**TOWN OF HUDSON
PLANNING BOARD
PUBLIC MEETING
TOWN OF HUDSON, NH
AUGUST 27, 2014**

Dairy Queen Amended Site Plan

Staff Report

SITE: 119 Ferry Street -- Map 175/Lot 142 --SP# 11-14

DATE: JULY 18, 2014 SCALE: 1" = 40'
 PROJECT NO: 14-0321-1 SHEET 1 OF 13

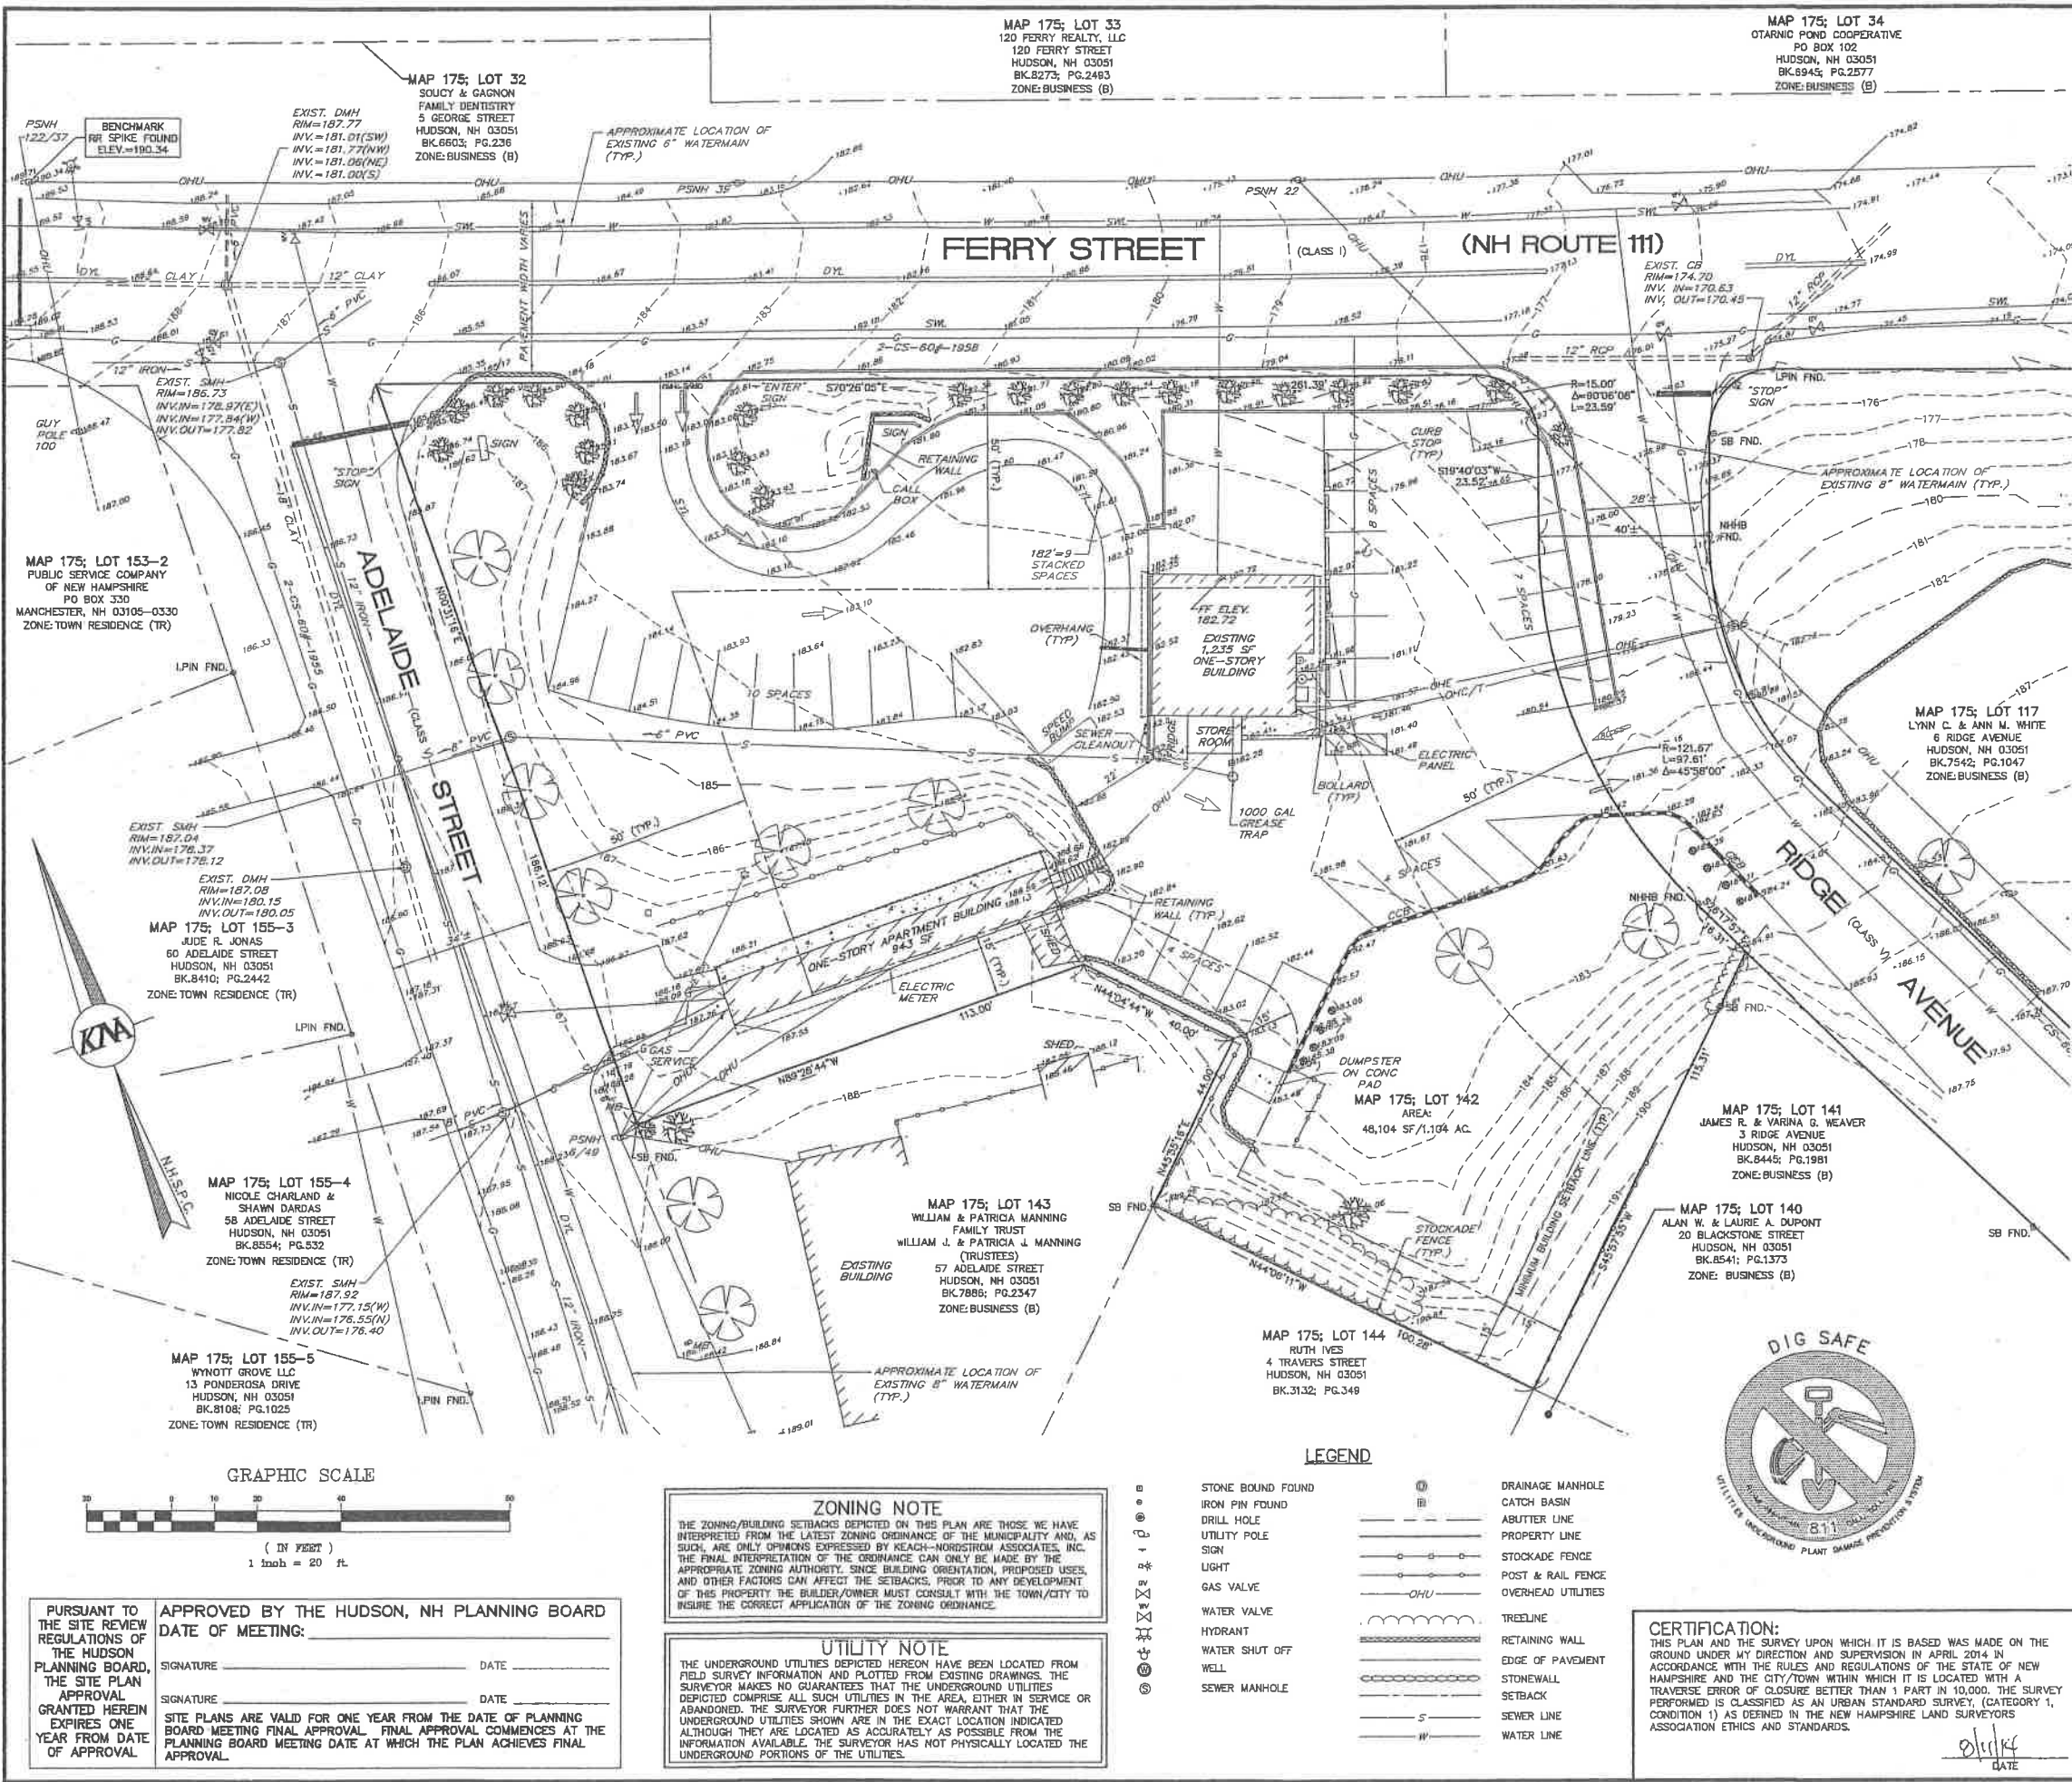
REQUESTED WAIVERS (shown in Note 19 of Master Plan Sheet 1 of 13):

I move to grant the requested waiver - HTC 275-8(B)24 – Open Space - because the existing site only provides 33.7% open space v. the proposed Site Plan providing 34.4%, which, although 0.6% less than the required 35% open space, does make the site more compliance with the ordinances, and therefore, the granting of this waiver moves in the direction of better providing for the spirit and intent of the ordinances.

I move to grant the requested waiver: HTC - 275-8(B)22 – Front Yard Green Space - because currently, as developed, the site contains 13 parking spaces within the 35 ft. green area buffer, and the proposed Site Plan calls for reducing this total to 9 spaces within said buffer, so although this proposal does not comply with the ordinances, it represents a reduction in the buffer encroachment, and therefore, the granting of this waiver moves in the direction of better providing for the spirit and intent of the ordinances.

DATE: JULY 18, 2014 SCALE: 1" = 20'
PROJECT NO: 14-0321-1 SHEET 2 OF 13

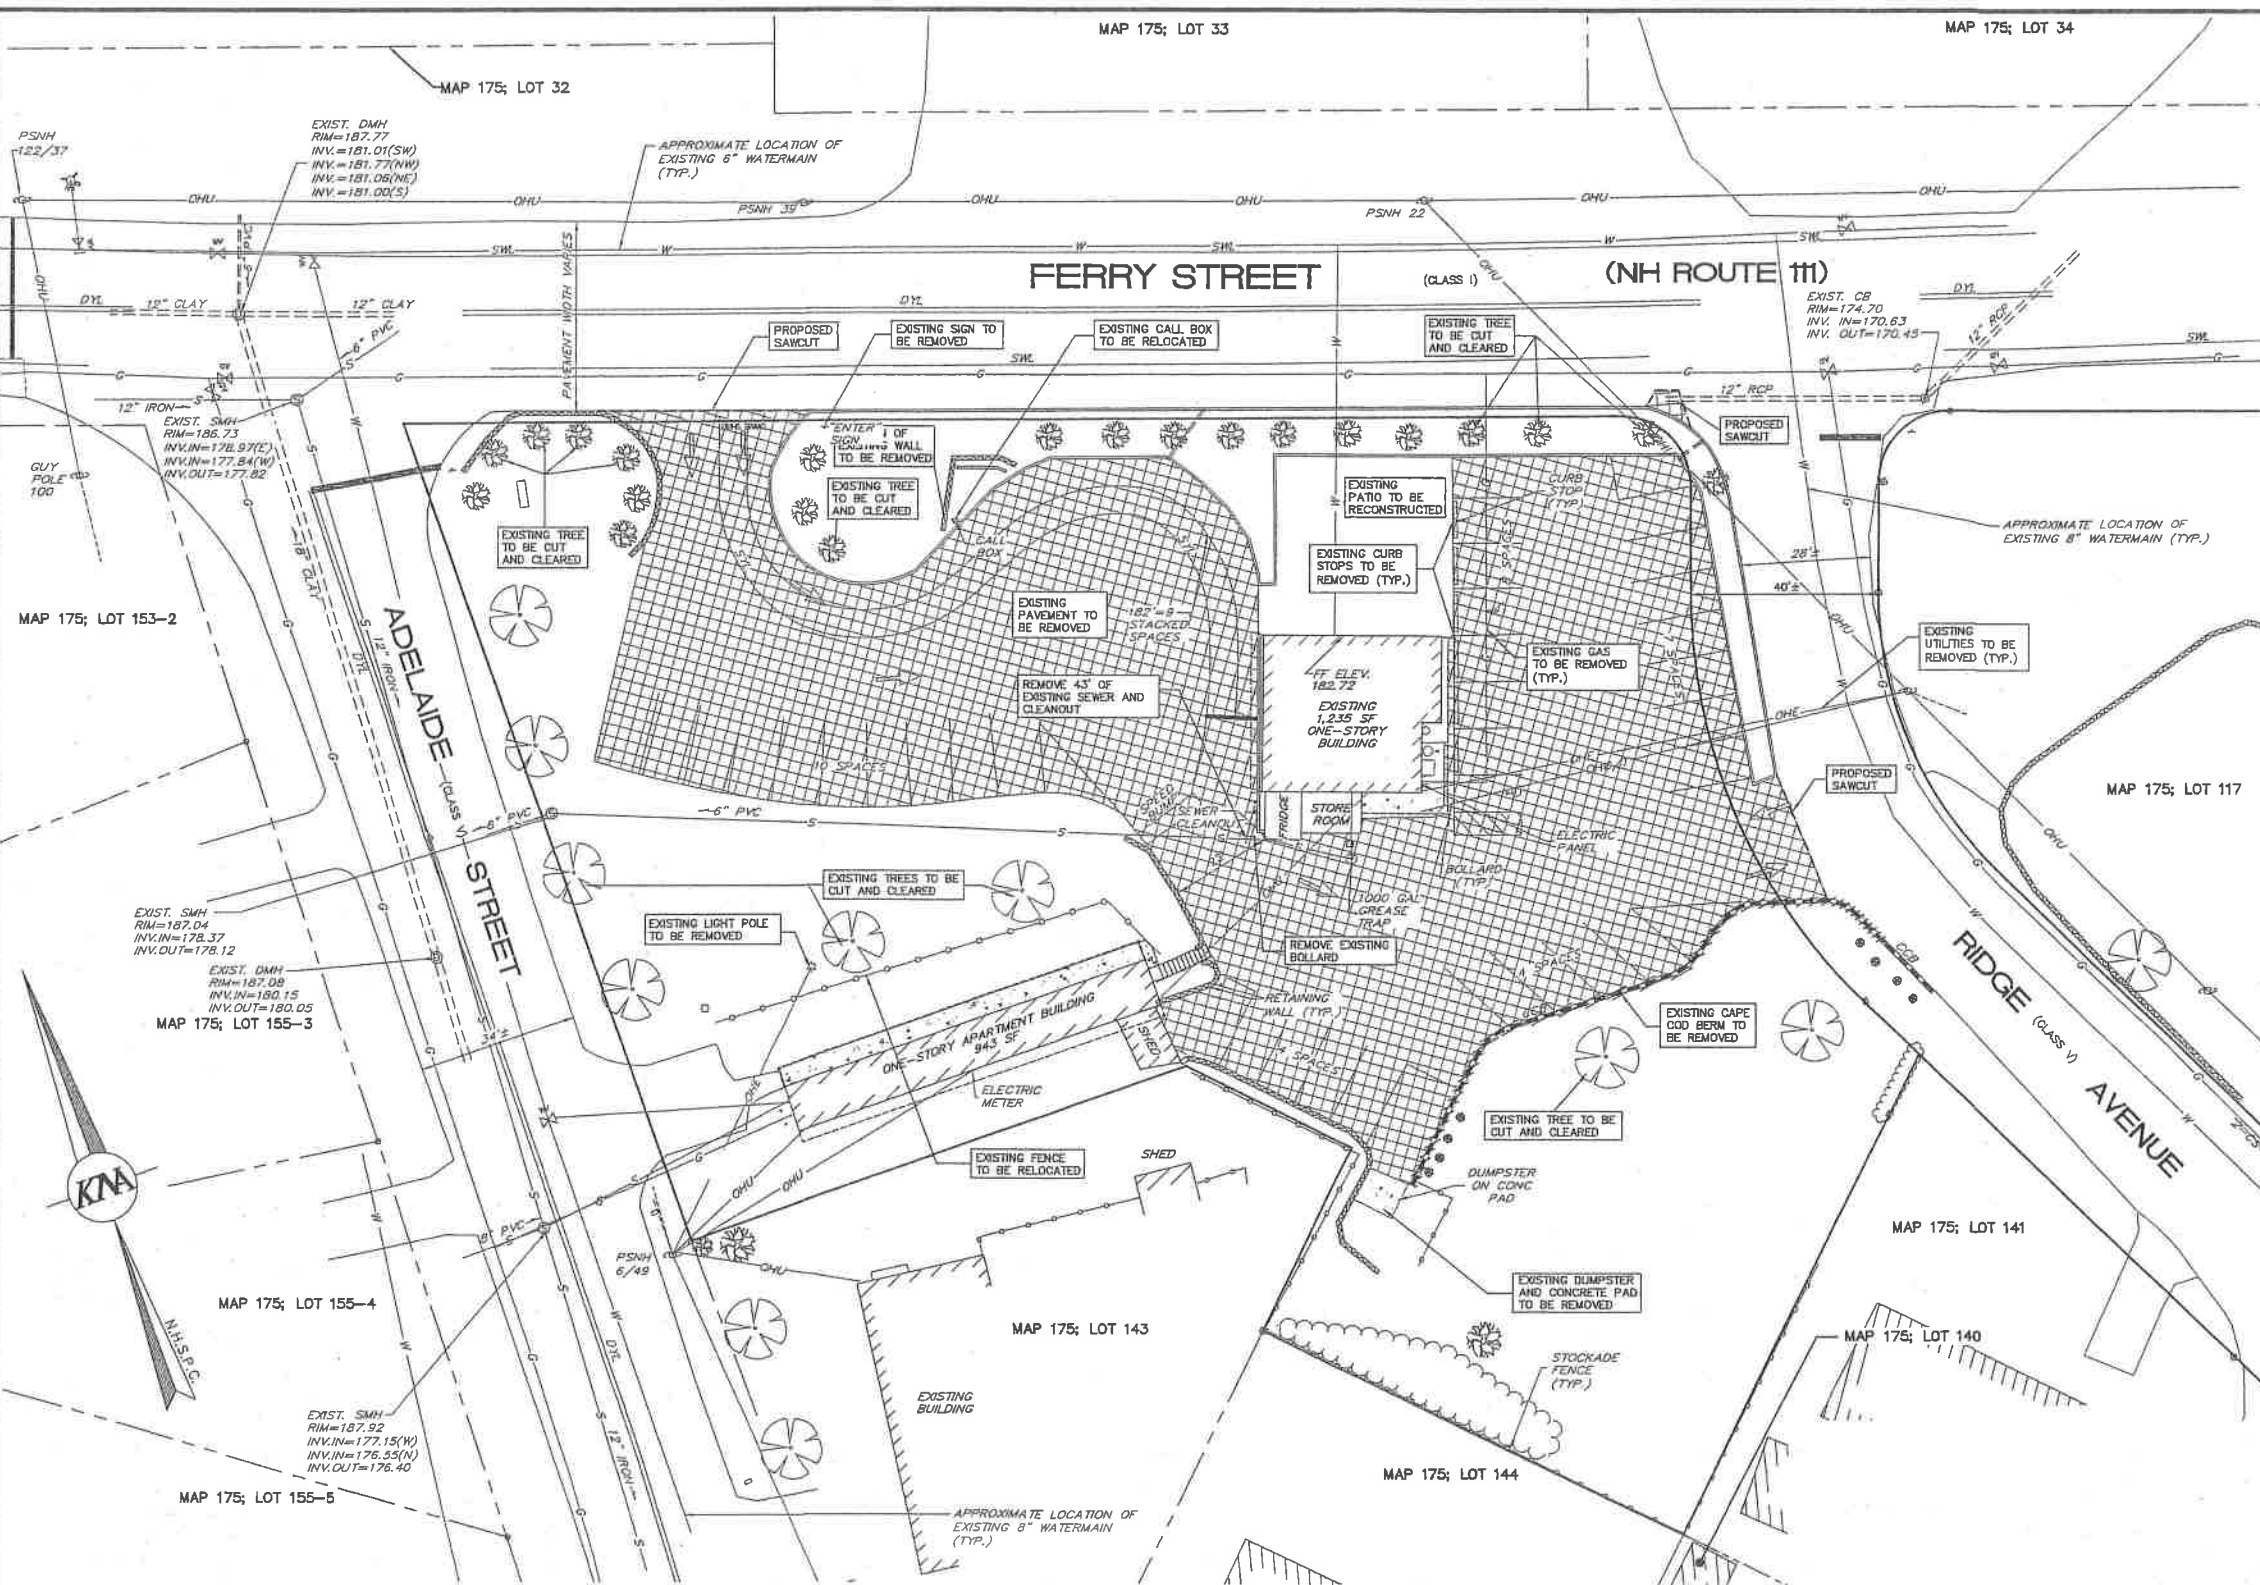
- A) With the proposed elimination of the existing Dairy Queen (DQ) driveway on Ferry St. and replacement of same along Adelaide St. (see Existing Conditions Plan, Sheet 2 of 13 and the Master Plan, Sheet 1 of 13), this new means of ingress/egress should make the existing Adelaide/Ferry/George Sts. intersection safer for vehicular travel.

DATE: JULY 18, 2014 SCALE: 1" = 20'
 PROJECT NO: 14-0321-1 SHEET 8 OF 13

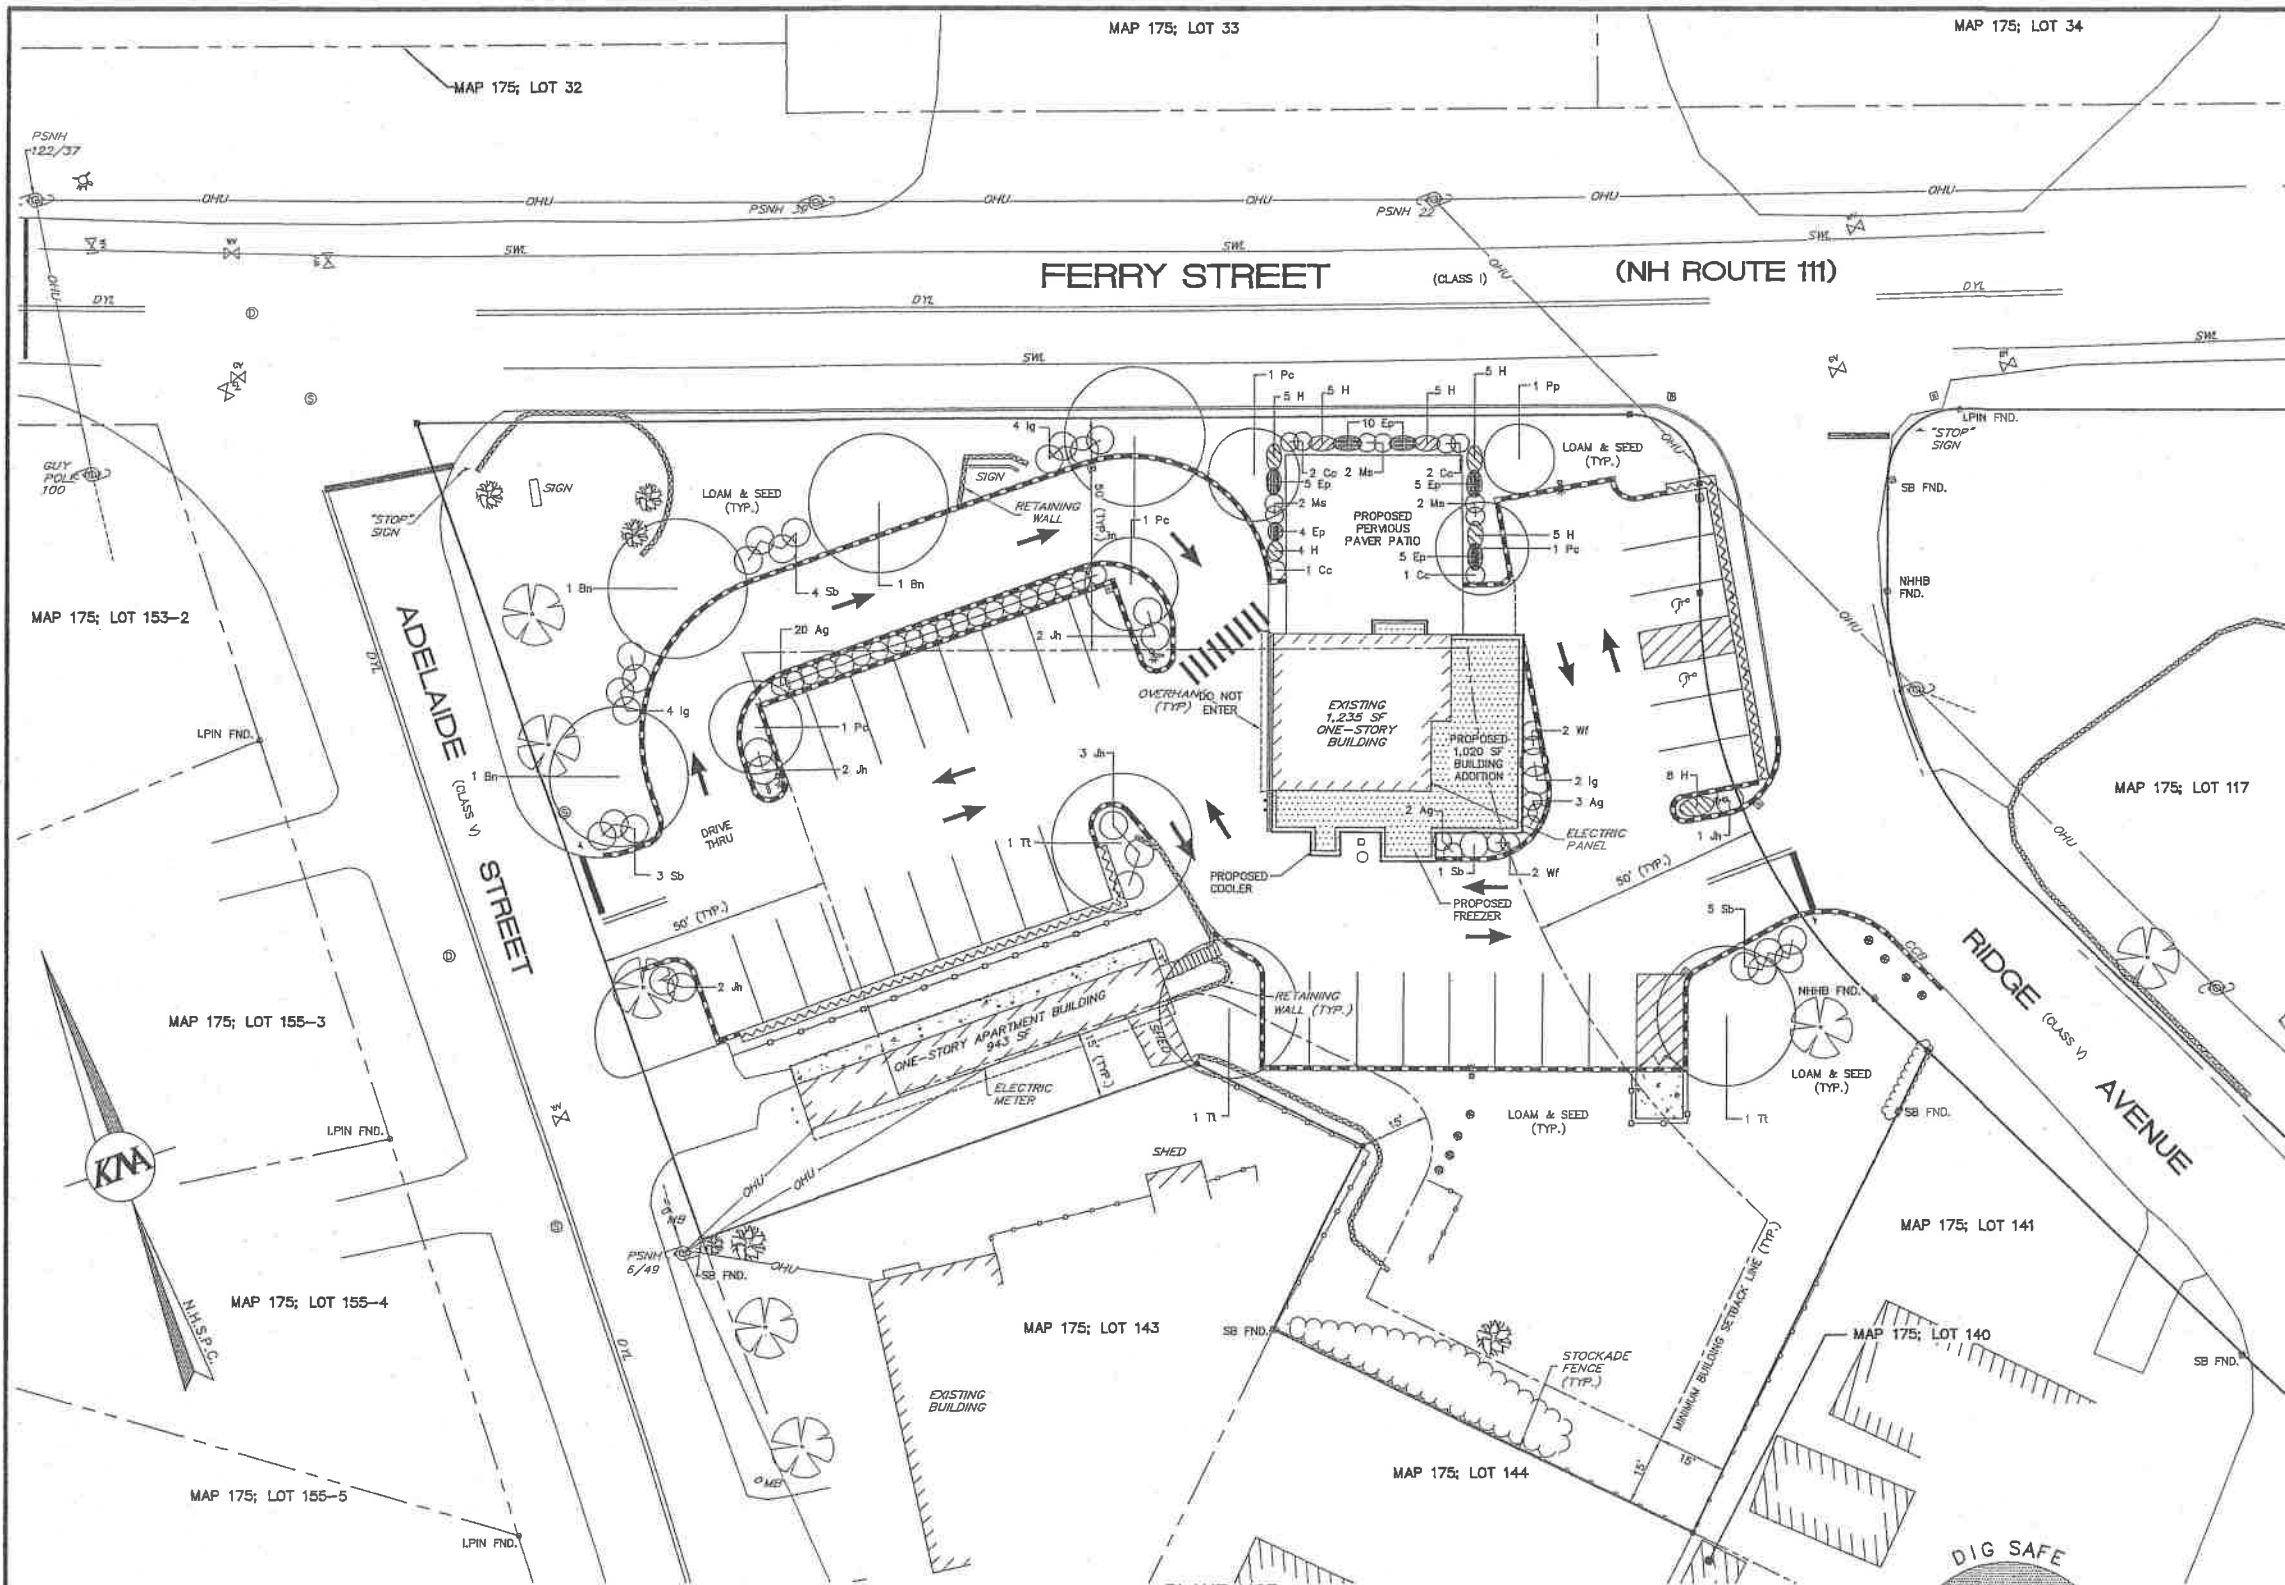
- 7) Onsite landscaping and exterior lighting shall be provided for in accordance with the Sheets 8 & 9 of the Plan.
- 8) Exterior construction activities on the site shall be limited to between 7:00 A.M. and 7:00 P.M. Monday through Saturday. No construction activities shall occur on Sunday.
